Mark B. Bezilla
Vice President440-280-5382
Fax: 440-280-8029September 9, 2011
L-11-267

Perry Nuclear Power Plant
Docket No. 50-440, License No. NPF-58
Response to Request for Additional Information Related to the 10 CFR 50.55a
Requests In Support of the Third 10-Year Inservice Inspection Interval
(TAC Nos. ME5376, ME5377, ME5379, ME5380, and ME5381)

Response to Request for Additional Information Related to Third 10-Year Inservice
Inspection Interval for Perry Nuclear Power Plant
Page 1 of 14

LPCS Pump

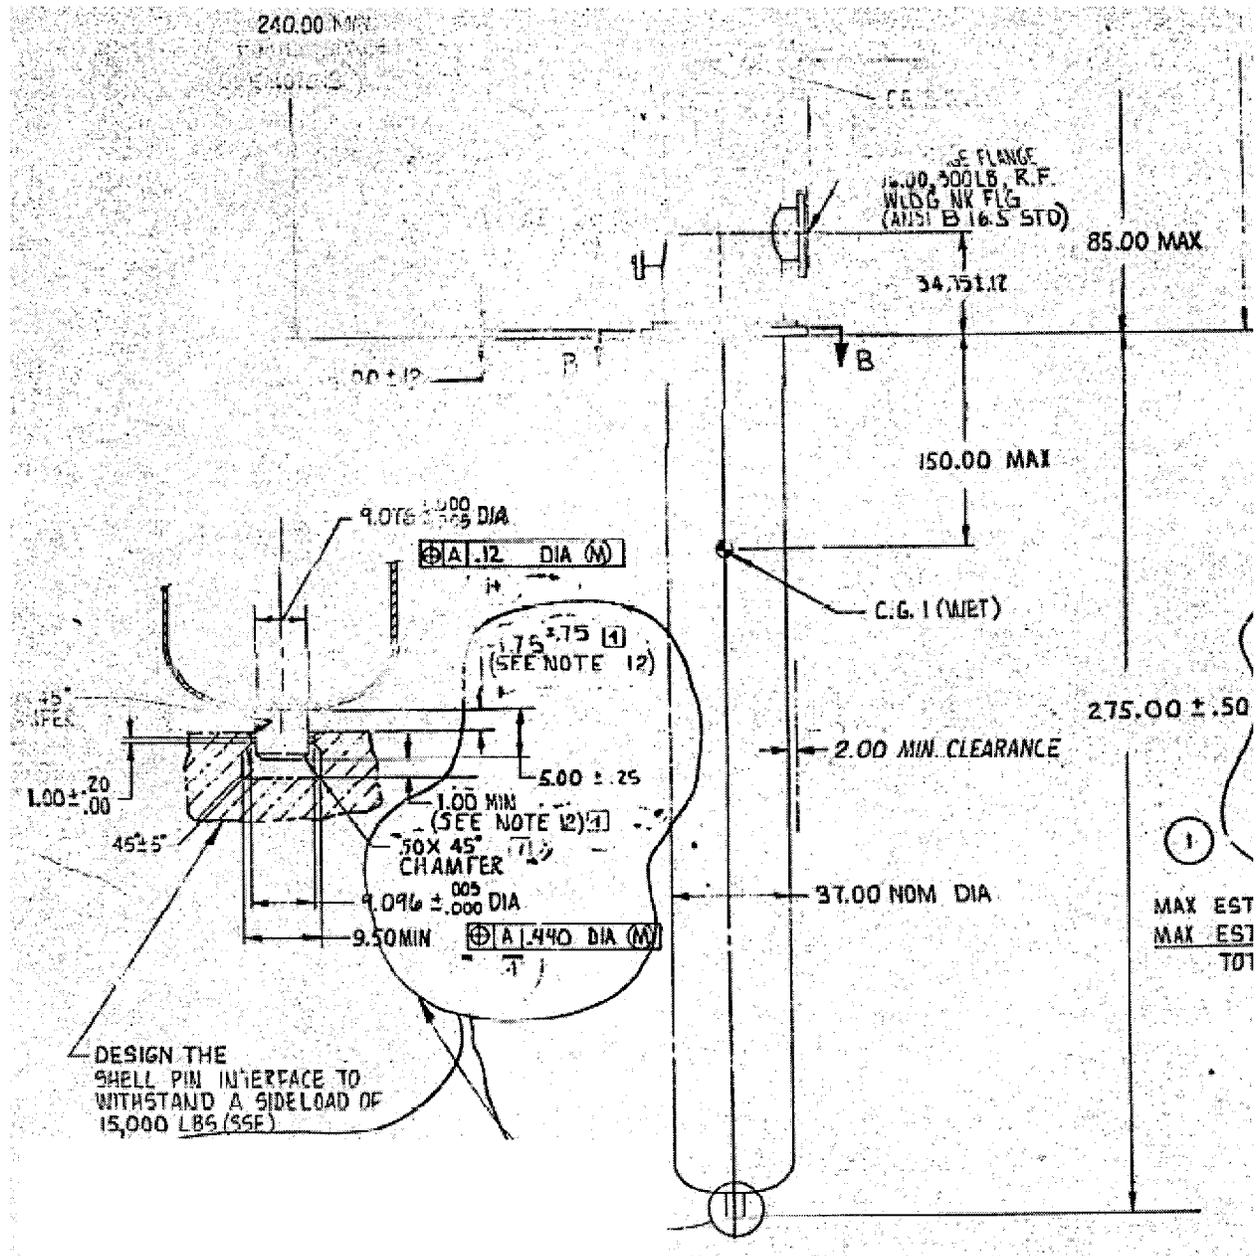
The licensee has provided a typical description and sketch of a pump casing. The description implies that the floor is preventing examinations of all of the casing welds.

- (a) Provide a sketch showing the restrictions. If the restrictions are associated with a pit, provide the approximate depth and annulus dimensions. Show the locations where the pump is in intimate contact with the supporting structure. If the casing below the floor is completely encased in concrete, provide the approximate depth of the encased casing.**
- (b) Provide a discussion on the accessibility for remote visual examinations performed from the outside or inside casing surface (including welds below the floor).**
- (c) Provide a percent estimate of a combined visual and surface examination of the pump casing.**
- (d) Identify the number of pumps in the group being represented by the residual heat removal pump A.**
- (e) Provide a discussion on the effects a crack pump casing weld would have on the functionality of the pump and the effects on the region outside the casing.**

The barrel flange (the sole plate for the pump) is grouted and bolted to the floor and is not designed for routine removal. Thus, the annular space between the pump barrels and the pit walls, which is approximately 4.5 inches for the RHR and LPCS pumps and 2.5 inches for the HPCS pump, is not accessible for surface or remote visual examination. As can be seen in the provided drawings of the pumps, the interior surfaces of the pump barrel welds are only accessible through the suction side of the pump. The only access for remote visual examination from inside the pump barrels is through a 3/4-inch vent connection in the head shell. From there, lowering the fiberscope and locating the barrel welds would be difficult and only those portions of the

circumferential barrel welds directly below the vent connection are able to be inspected. Lowering the fiberscope from the vent connection does not allow for control of the focal distances, making it unlikely that images of sufficient quality could be obtained, even for the very limited areas that could be seen. Based on the above, it is unlikely that any percentage of visual examinations could be credited for distance, lighting, and acuity requirements.

Each of the ECCS pumps has 15 Category C-G, Item C6.10, casing welds of which eight (approximately 53 percent) are accessible. Those on the selected pumps receive the required surface examinations each inspection interval. For the seven casing welds in the barrel below the floor, no examinations are performed.
